TRANS/WP.29/873
19 July 2002

World Forum for Harmonization of Vehicle Regulations (WP.29)

DRAFT SUPPLEMENT 2 TO THE 01 SERIES OF AMENDMENTS
TO REGULATION No. 94

(Frontal collision protection)

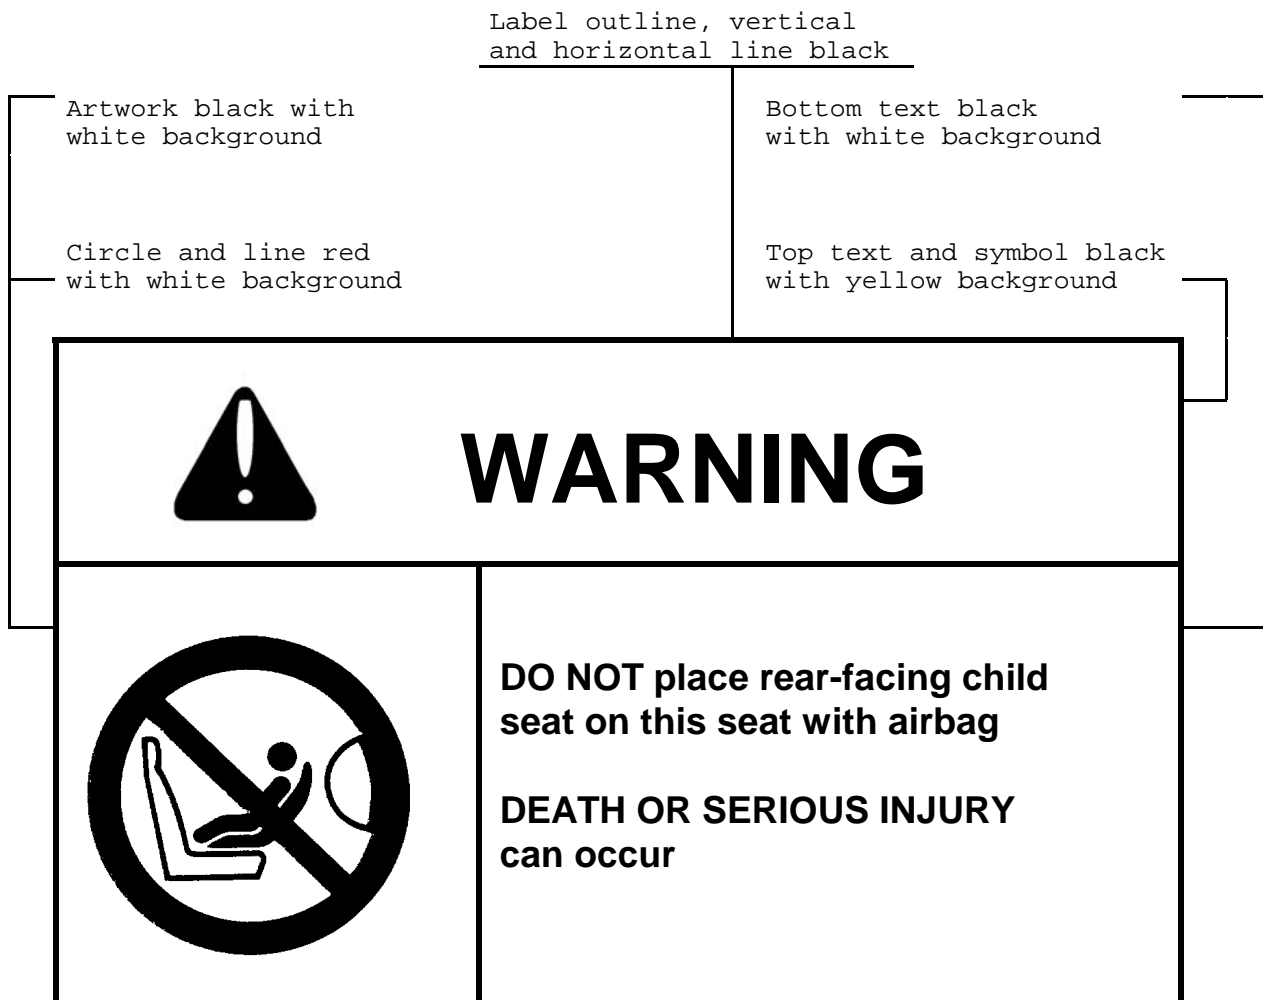
6.2. A vehicle fitted with one or more passenger frontal protection airbags shall carry information about the extreme hazard associated with the use of rearward-facing child restraints on seats equipped with airbag assemblies.

6.2.1. As a minimum, this information shall consist of a label containing a pictogram and text warning as indicated below.

The overall dimensions shall be 120 x 60 mm or the equivalent area, as a minimum.

The label shown above may be adapted in such a way that the layout differs from the example above; however, the text content shall meet the above prescriptions.
